RECEIPT DATE: 3-28-25 **ONSITE SEWAGE DISPOSAL SYSTEM** P 589012

PROPERTY ADDRESS: 11813 Chapel Woods Court

**From:** Silvast, Zackary  
**Sent:** Friday, January 20, 2023 5:38 PM  
**To:** Zach Sill; Paul Sill  
**Cc:** Williams, Jeffrey; Bernard, Dana  
**Subject:** regarding 11813 Chapel Woods Court

**ONSITE SEWAGE DISPOSAL SYSTEM PLAN**  
**CHANDE PROPERTY**  
 1183 CHAPEL WOODS COURT  
 LOT 2 HALLMAN'S PROPERTY  
 HOWARD COUNTY, MARYLAND

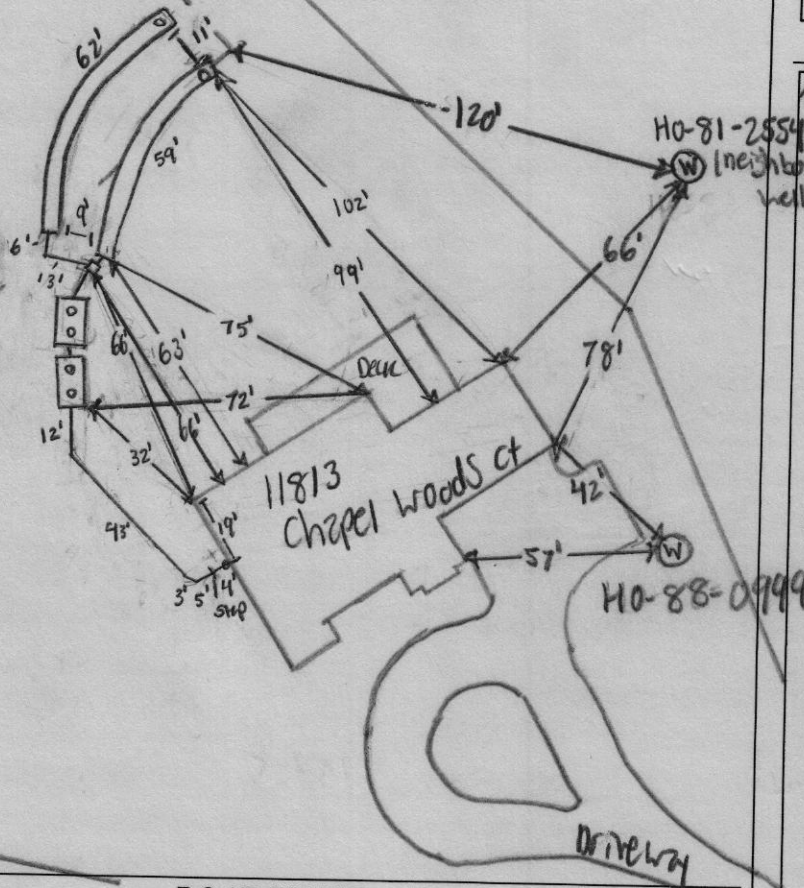
5/16/2025 - Installer onsite for pre-con. Tank stacked per plan.  
 Trenches stacked per plan. Trenches ~ 60' long & on contour within 4". Neighboring well > 100' from septic. Well serving house missing cap & > 100' from septic. Contacting builder for well. Contractor OK to start work. SP/MVB

5/19/2025 - Installer onsite for inspection. Lower trench finished, ends open. Length @ 62', inlet @ 3', stone & fabric OK. Installer finishing upper trench while onsite. Length @ 59', inlet @ 3', stone & fabric OK. OK to backfill. SP  
 5/20/2025 - Installer onsite for inspection. Tank set while onsite. D-box tied into trenches & tank. Levelled d-box. OK to backfill back line, reinspect for front line connection.  
 Installer onsite for inspection in PM. Adequate fall to tank. SW 6" front baffle & 4" baffles. OK to backfill all work. SP

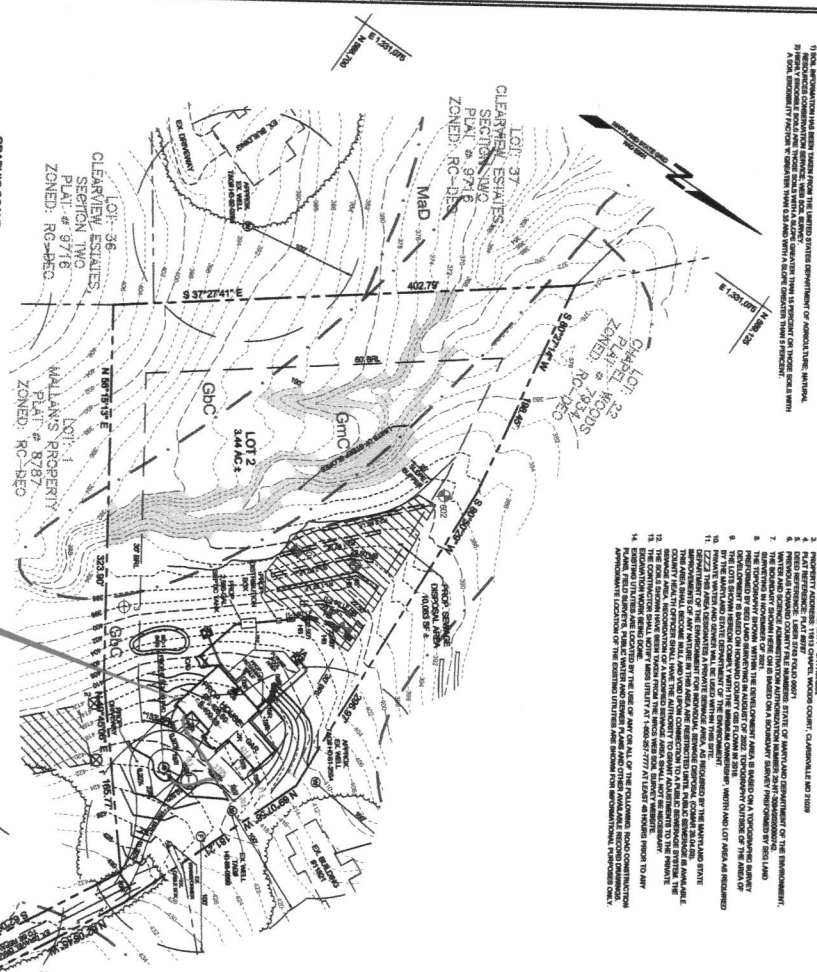
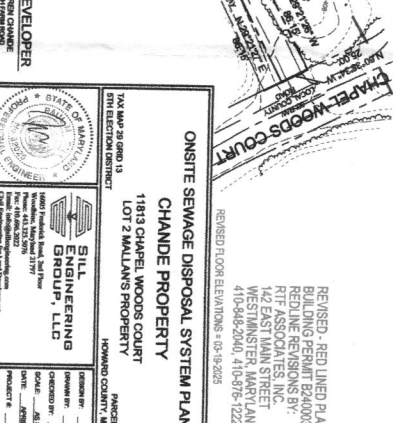
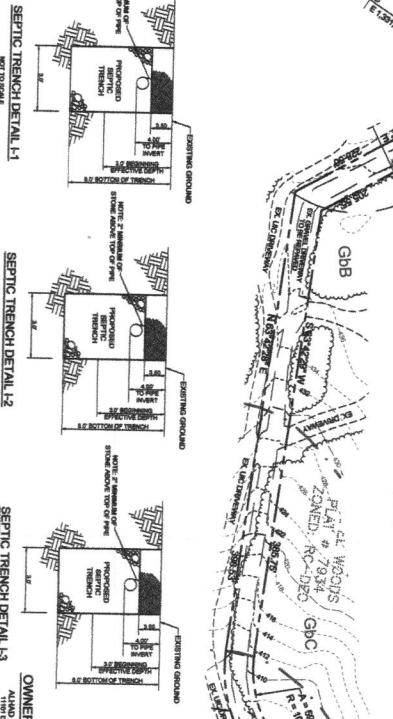
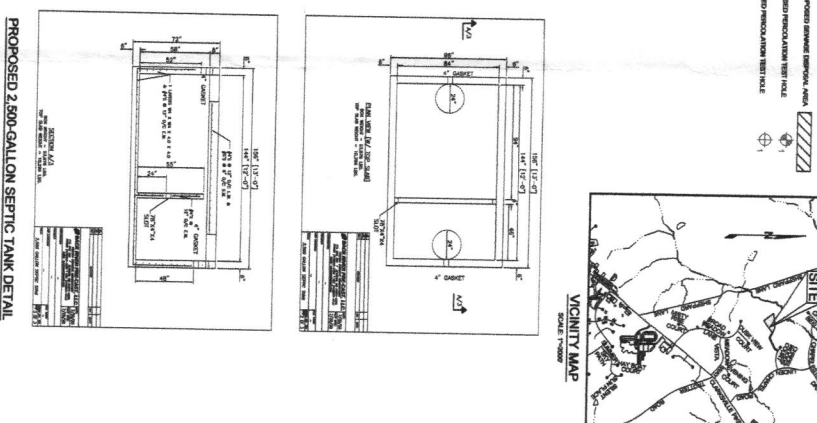
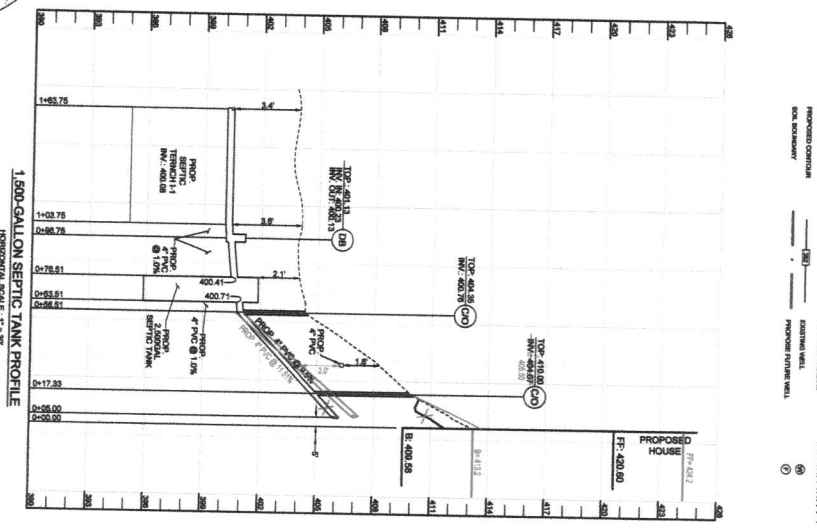
1. **The overall topography shown on this plat is not adequate since over 50% of the plat is either extremely faded or unreadable.**
  - a. **The topography should be located in a way that is apparent on the lot.**
  - b. **I almost thought there was missing topography, until I realized it was hugging the property lines on the outside portion of the lot.**
2. **Greater than 25% slopes needs to be shown in a clearer and more decipherable way.**
  - a. **Should be visually striking/differentiable.**
  - b. **Should be added to the legend.**
3. **A master well driller must submit a report stating that the alternate well site across the ravine/swale divide is accessible.**
  - a. **An appropriate note should make mention of this.**
4. **Temporary ditch crossing is not an acceptable note for the plan. That doesn't show specifically what is being done or how. Please change.**

1. ***The alternate/future well site is a concern, how are they going to gain access? It should be shown accordingly.***
2. ***The Environmental Report submitted by the engineering firm was not adequate as it lacked information.***
  - a. ***The letter's creator from the environmental firm did not provide any of "his/her/their" credentials.***
  - b. ***Generally, some "body of field work" they conducted would be provided with this letter/memo.***
    1. ***No data provided.***
    2. ***Therefore, it is currently not acceptable by Howard County Health Department standards.***

- Paul will provide report w/ photos with next submittal. I've reviewed + confirmed this is not a stream
- Paul will remove 3rd well site + include waiver request for only 2 well sites. We will approve.
